# Application for Planning Approval

**SA2023/025**

**9 MUNDAY STREET, BRIGHTON**

**SUBDIVISION (2 LOTS)**

| Title       | GENERAL ARRANGEMENT                           |

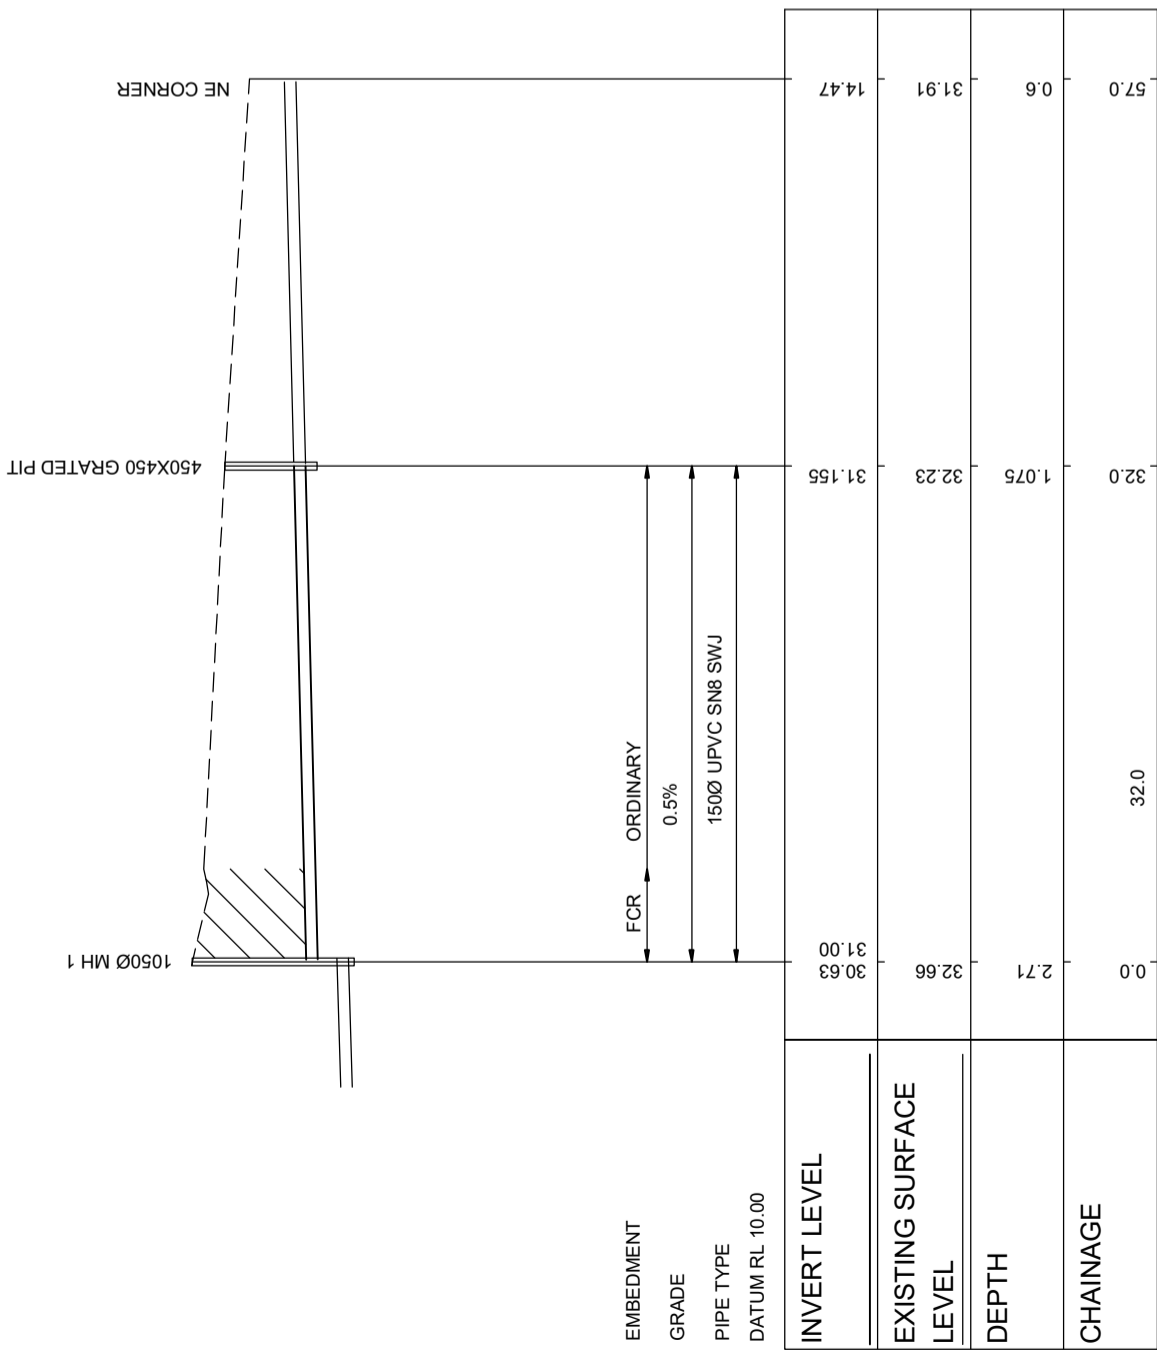
I refer to your RFI dated 5 September.

- The stormwater has been designed down the driveway to the existing pit in the road.
- Lot 1 will have a right of way over the access to lot 2 to access its rear.

- Tasrail were concerned about the 1.5m offset shown from their boundary. The actual closest a build could be to the boundary is 4m due to the pipeline easement.
- Tasrail were concerned at the sewer easement close to the boundary. The sewer is already there. The excavation for the connection is 4m from the boundary.
- The requirement for a 1.8m high fence it noted. It is believed it is already 1.8m high.
